Service Bulletin: SB 86

GAMES: Jack*Bot and Congo sample games manufactured before 12-15-95

SUBJECT: Premature loss of battery voltage on the WPC-95 CPU Board

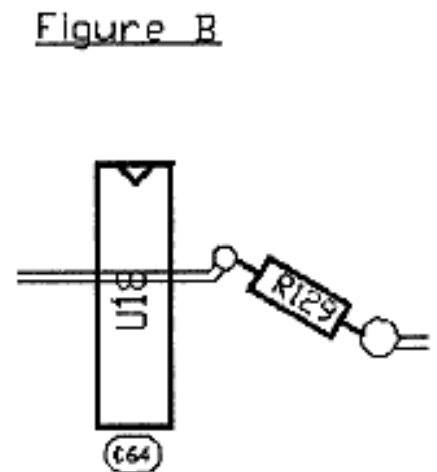
* Cut trace on the component side of the PCB as shown in Figure A. Tack solder the cathode of a 1N5817 1.0A diode (D28 on drawing and later board revisions) to U21 pin 2 as shown. Solder a short piece of insulated wire from the anode end of D28 to the feedthrough hole *near* U12 pin 20 as shown in Figure A.

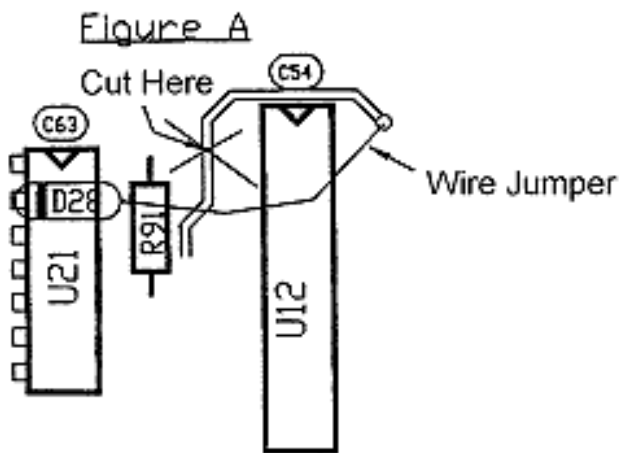
* Solder a 22K ohm 5% 1/4W resistor (R129 on drawing and later board revisions) to the feedthrough holes in the PCB *near* U18 as shown in Figure B.
